Nomination Form
Anadromous Waters Catalog

Region Interior USGS Quad(s) HEALY D-5
 Anadromous Waters Catalog Number of Water Body 334-40-11000-2490-3200 (-4079)
 Name of Water Body Nenana River, unnamed tributary USGS Name Local Name
 Addition Deletion Correction Backup Information

Nomination #	<u>25-687</u>	<u>[Signature]</u>	<u>10/25/2025</u>
		Fisheries Scientist	Date
Revision Year:	<u>2026</u>	<u>[Signature]</u>	<u>10/24/25</u>
		Habitat Operations Manager	Date
Revision to:	<input checked="" type="checkbox"/> Atlas <input checked="" type="checkbox"/> Catalog	<u>[Signature]</u>	<u>26 Sept 2025</u>
		AWC Project Biologist	Date
Revision Code:	<u>C-9, F-1</u>	<u>[Signature]</u>	<u>10/29/2025</u>
		GIS Analyst	Date

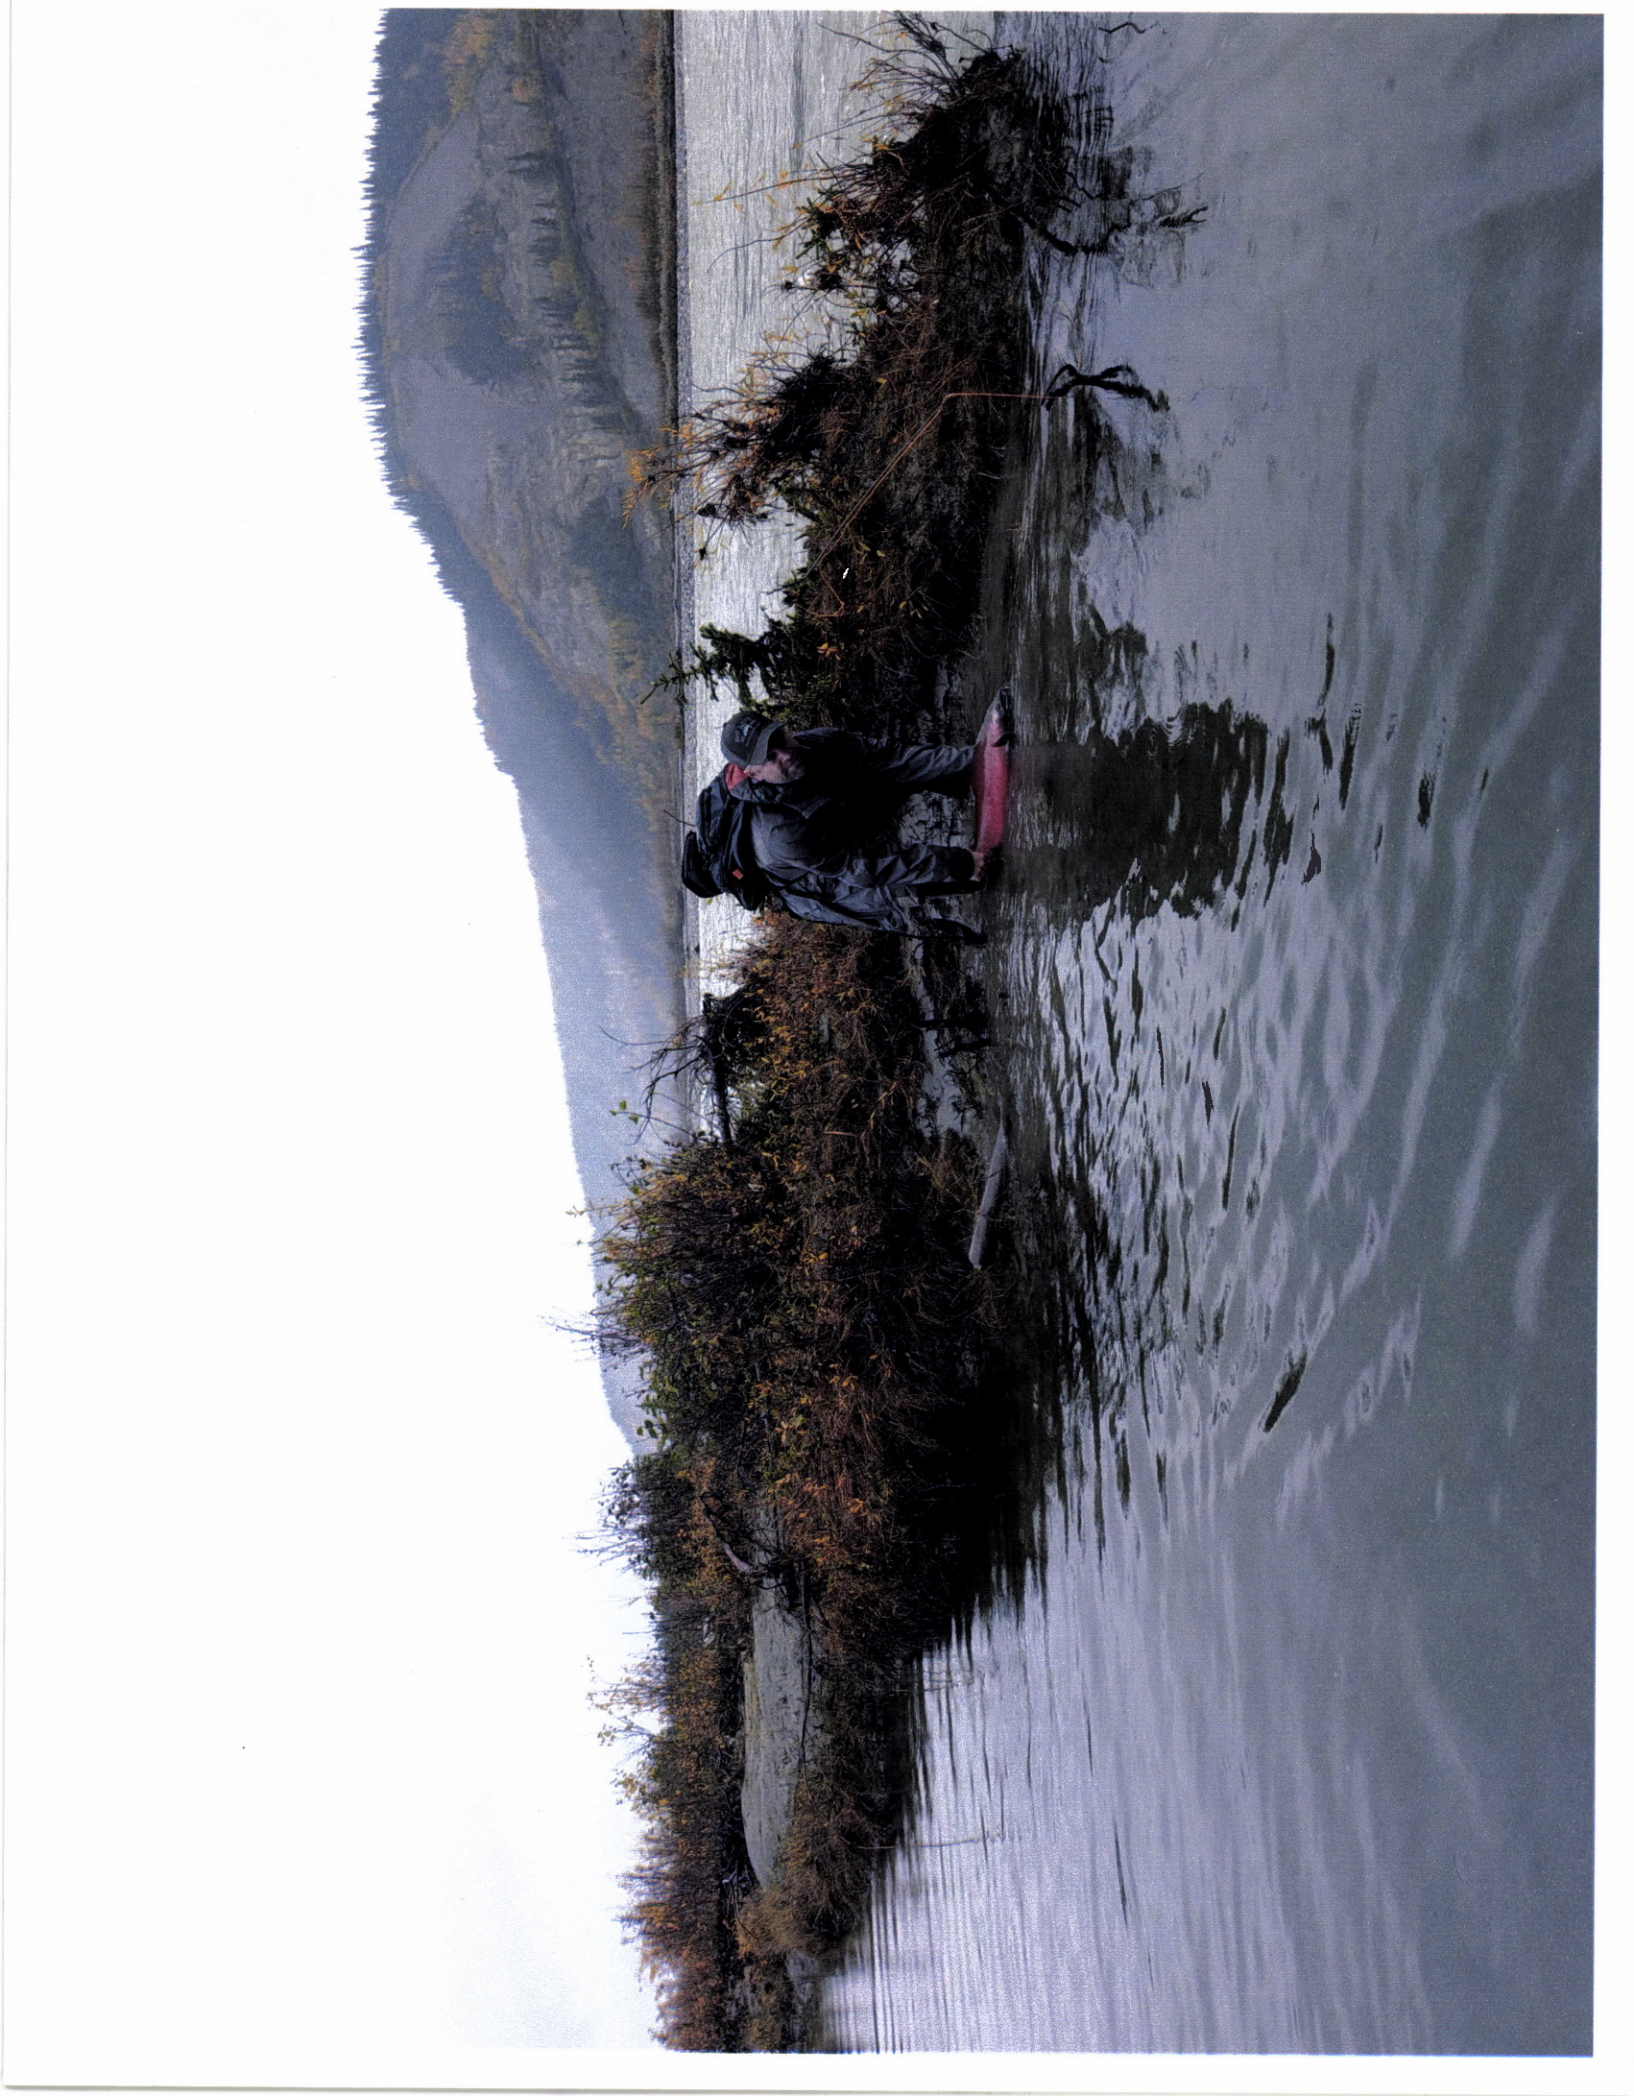
I wanted to follow up on your nomination to the AWC to make sure I'm interpreting your comments about the hydrography correctly and where the outlet should be?

Do you think that #334-40-11000-2490-3200-4079 actually flows into 334-40-11000-2490-3200-4075 "Panguingue Creek" or does it flow out where the larger red circle was in the map you included in the submission?

Yellow lines in the below image are from the NHD and match your comments but I wanted to be sure it hadn't changed to a different outlet location.

Hi Joe, the creek ending in 4079 with the coho we saw (currently) flows directly into the Nenana River at the point circled in red and not into Panguingue Creek. But there is very heavy beaver activity in these creeks so I think it does change from time to time!

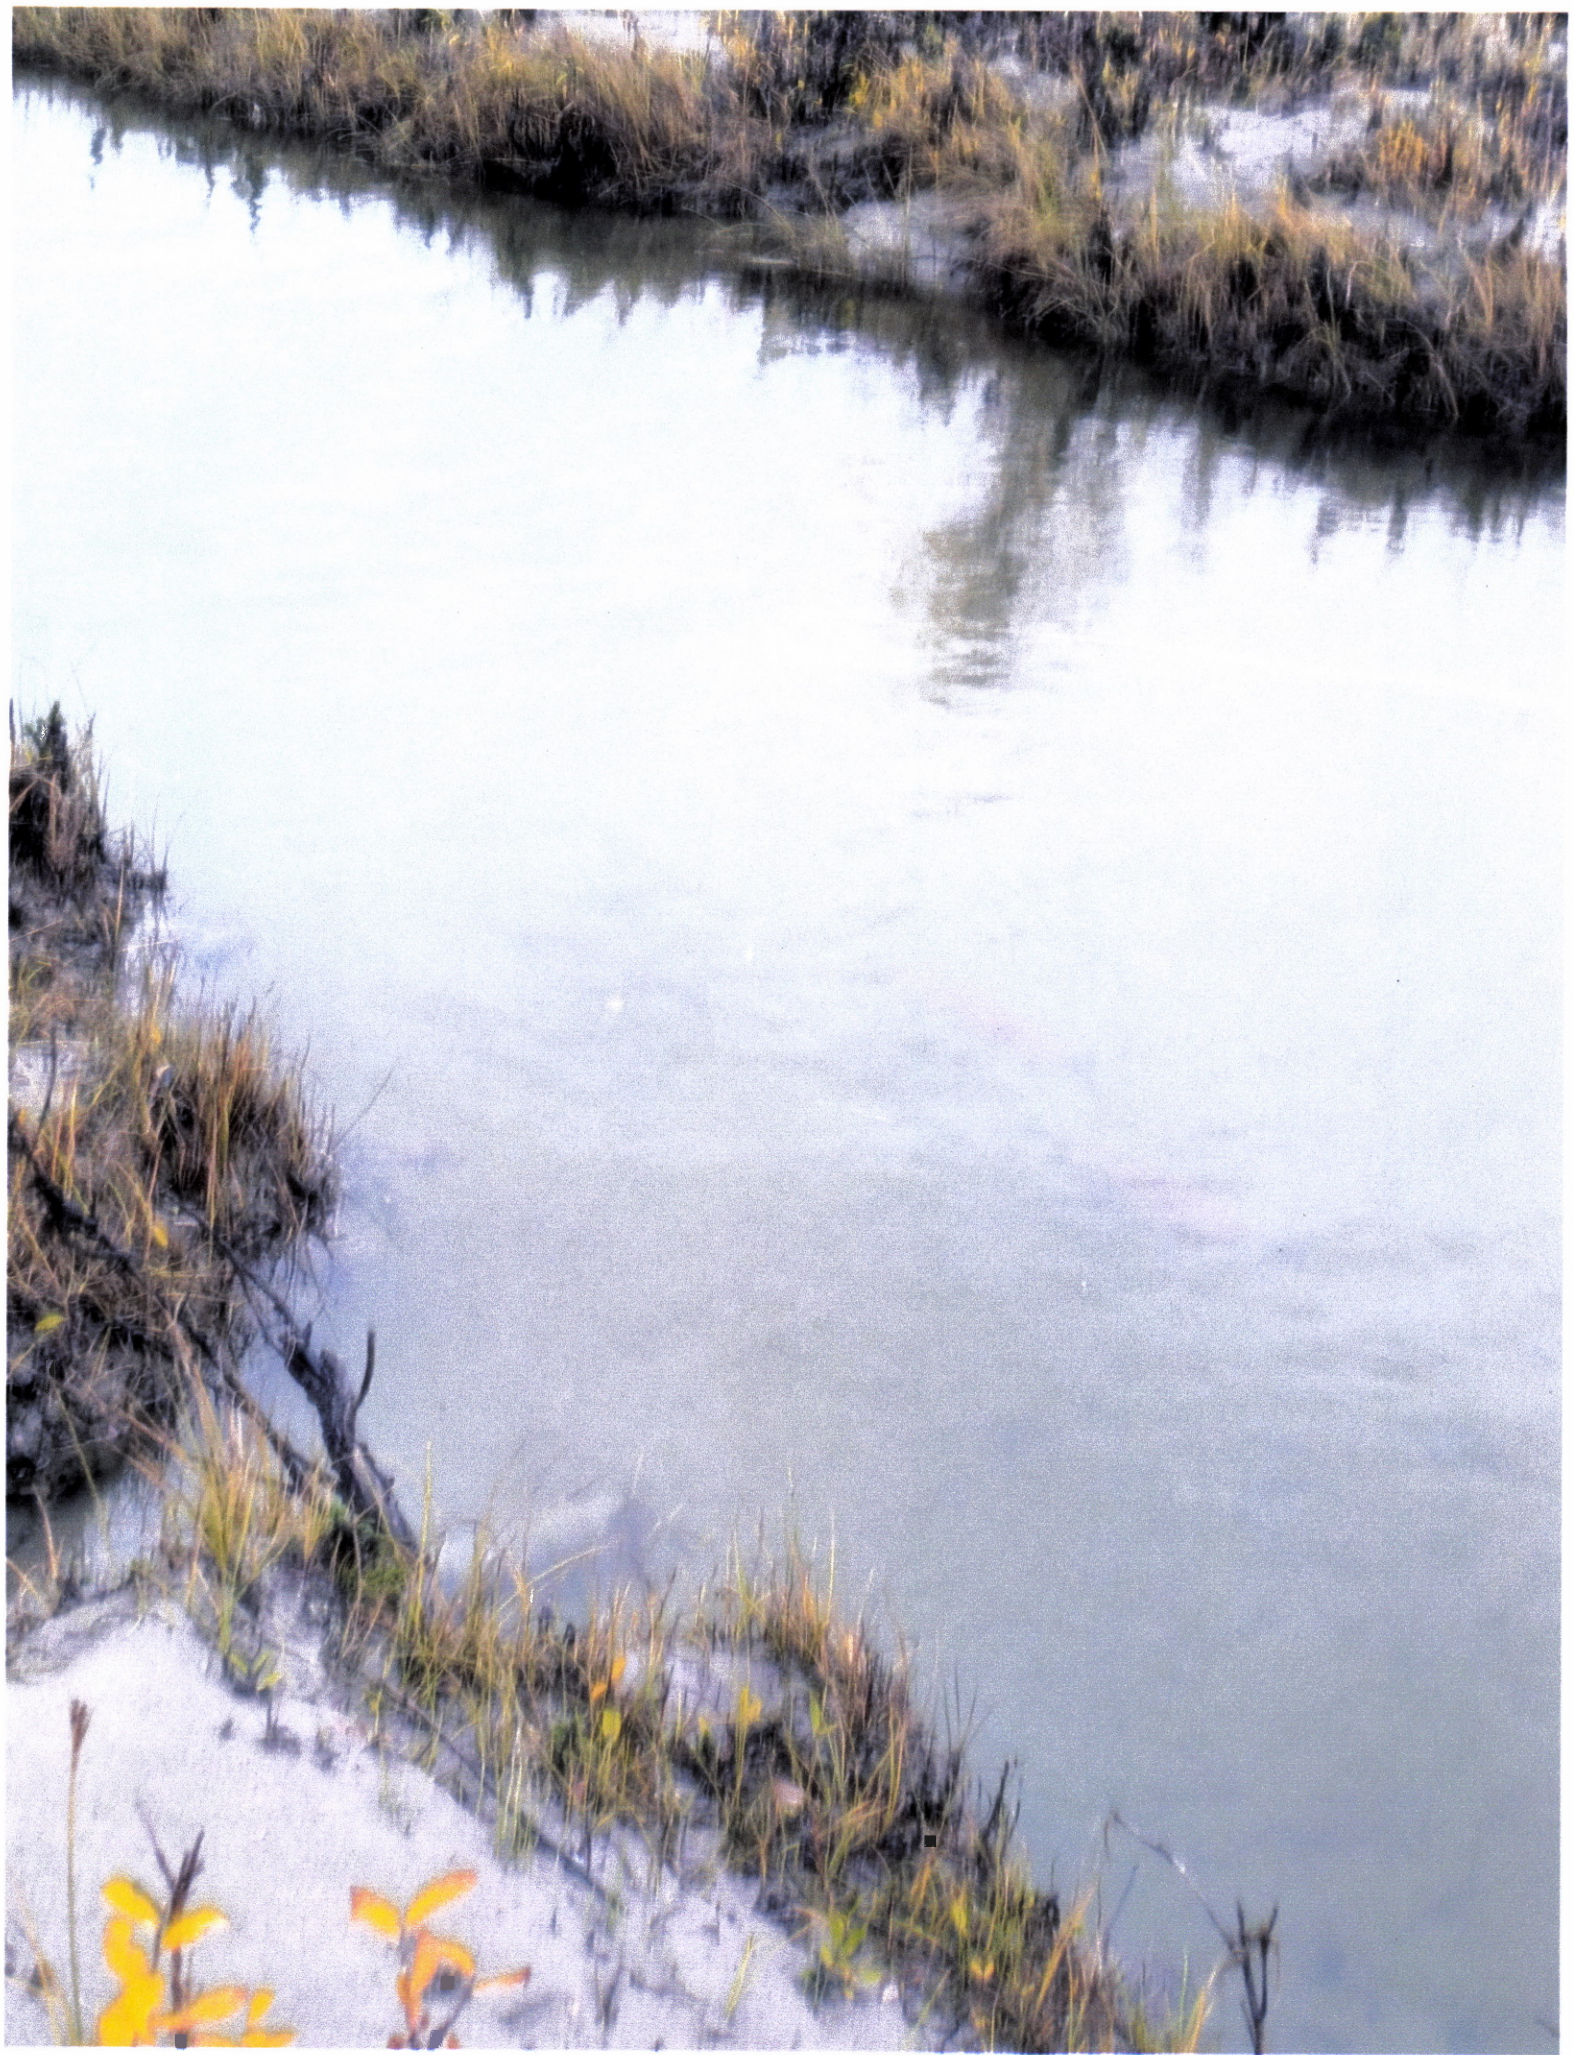
Attaching a photo of a massive dam on Panguingue Creek a bit below the RR bridge that must block coho from going up.

Map # 1

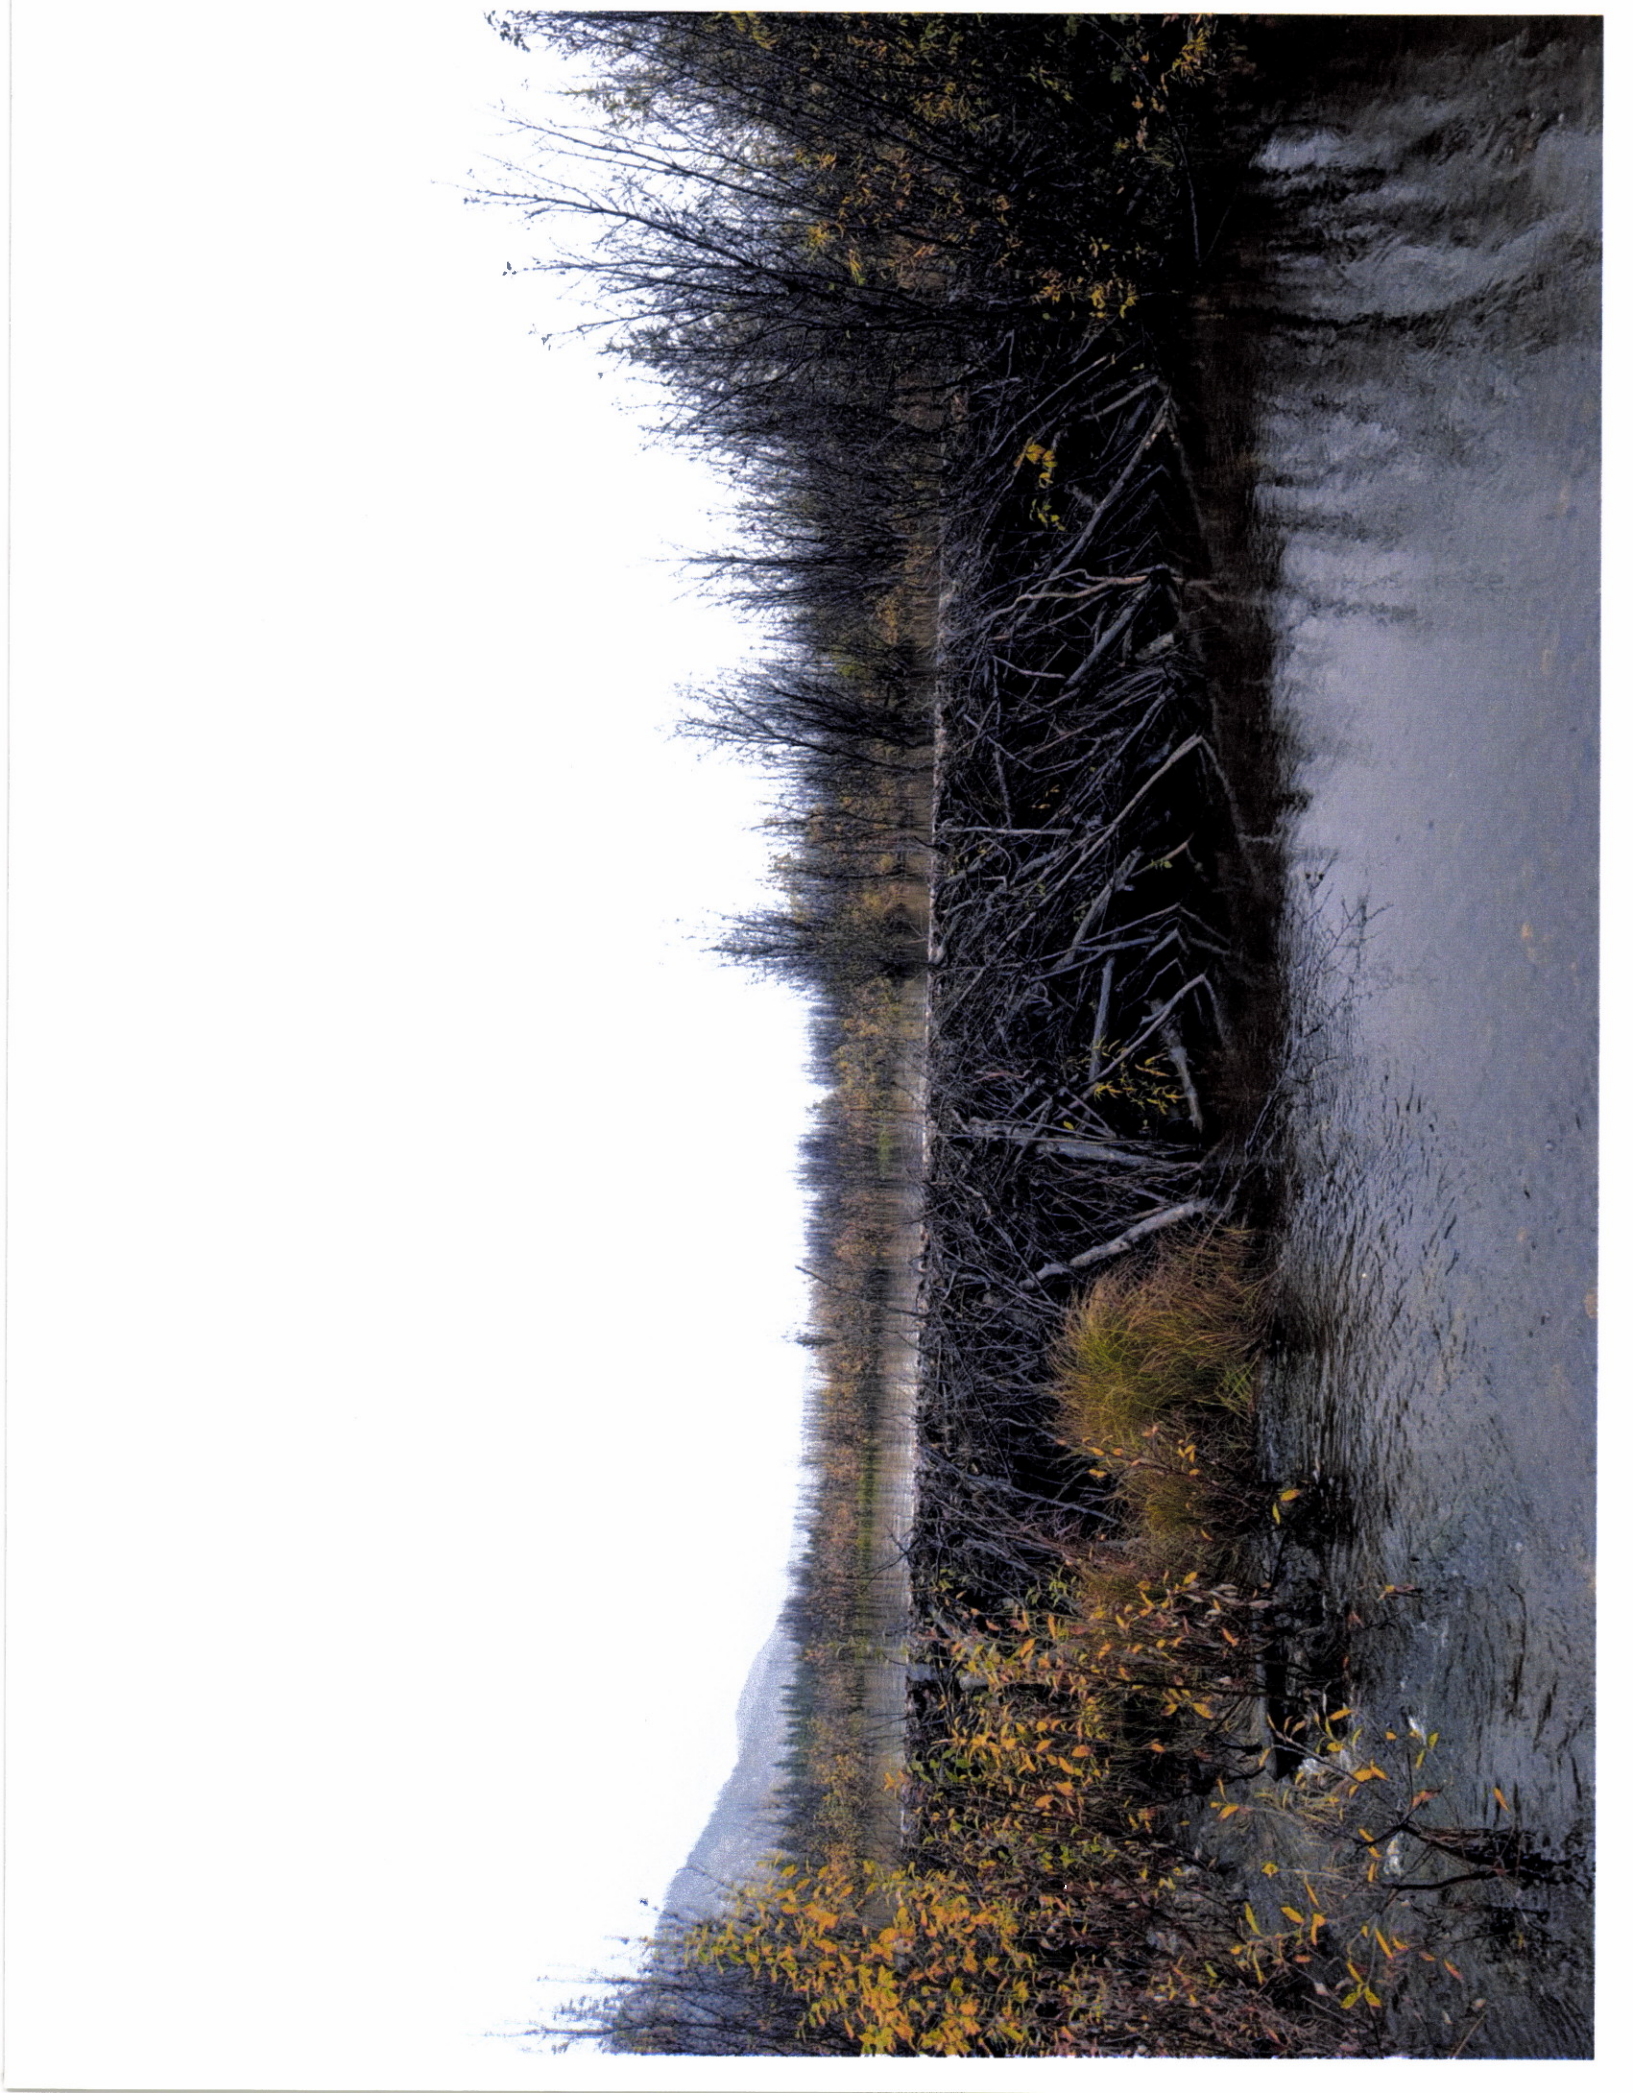
-UPDATE/ADJUST hydrography segment of existing AWC Stream #334-40-11000-2490-3200 "Nenana River"

-UPDATE/ADJUST hydrography including new stream mouth point location of existing AWC Stream #334-40-11000-2490-3200-4079.

+ Please update using most recent .GDB with line, point, lake, polygon and barrier features located in O:\DSPR5\AWC\Draft2026\GISData\AWC2026_WrkingV1_7April2025.gdb
